SECTION D-D

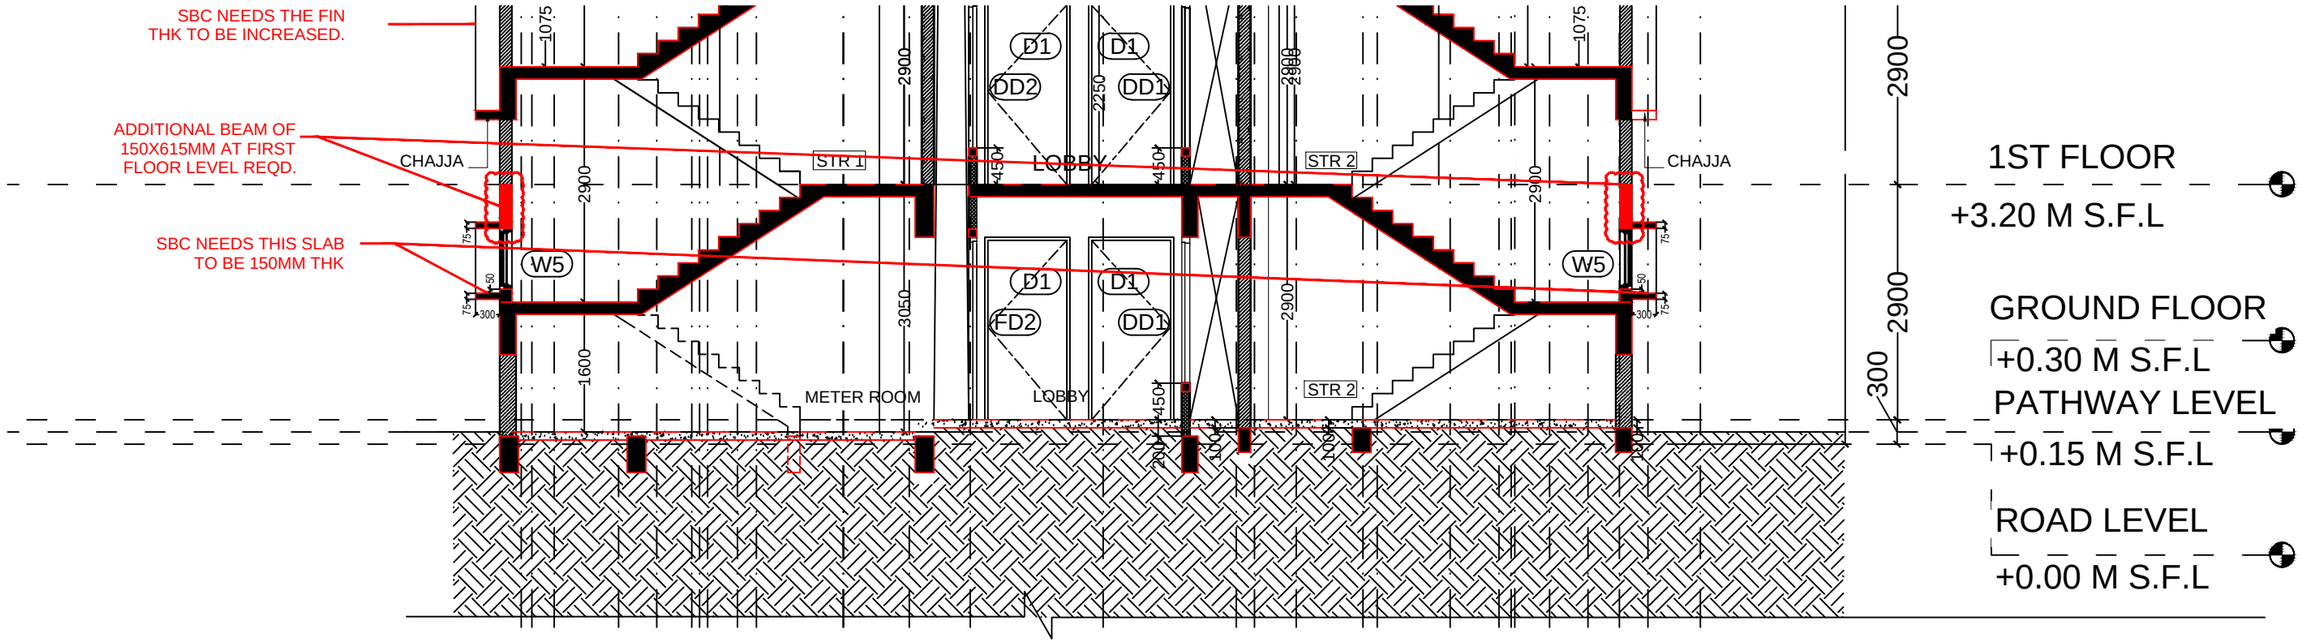
SBC NEEDS THE FIN THK TO BE INCREASED.
ADDITIONAL BEAM OF 150X615MM AT FIRST FLOOR LEVEL REQD.
SBC NEEDS THIS SLAB TO BE 150MM THK
CHAJJA
CHAJJA
STR 1
STR 2
STR 2
LOBBY
LOBBY
METER ROOM
D1
D1
DD2
DD1
D1
D1
FD2
DD1
W5
W5
1075
1075
2900
2900
2900
2900
2900
2900
2250
3050
1600
450
450
450
300
1ST FLOOR
+3.20 M S.F.L
GROUND FLOOR
+0.30 M S.F.L
PATHWAY LEVEL
+0.15 M S.F.L
ROAD LEVEL
+0.00 M S.F.L
